**TOWN OF HORIZON CITY  
MEMORANDUM**

**SUBJECT:** On the **Preliminary and Final Subdivision Plat** application for **Rancho Desierto Bello Unit 17 (Case No. SUC24-0002)** and to authorize the Mayor to sign the recording plat, legally described as A Portion of Leigh Clark Survey No. 297, Town of Horizon City, El Paso County, Texas. Containing 19.647 ± acres. Application submitted by Applicant/Representative: TRE & Associates.

**TOWN OF HORIZON CITY  
Planning and Zoning Commission Staff Report**

**Case No.:** **SUC24-0002**  
*Rancho Desierto Bello Unit Seventeen (RDB U-17)*

**Attachment 4- Preliminary Plat**

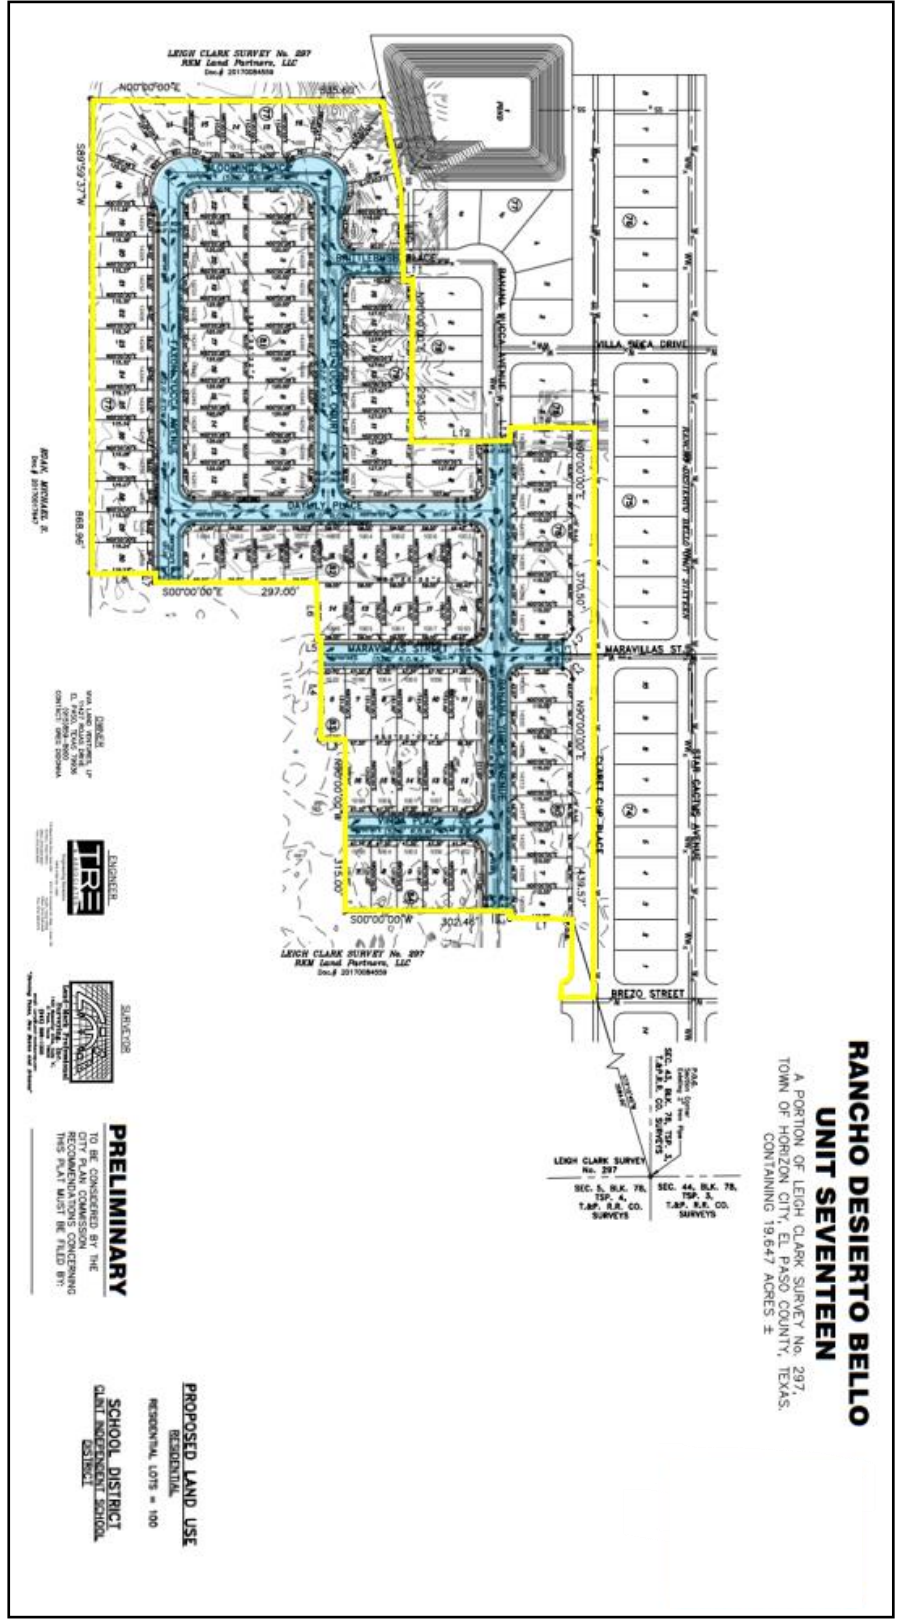
Please correct 34 lots that do not meet the minimum lot width required of 50 ft. for R-9 (Single Family Dwelling) zoning district as marked on plat.
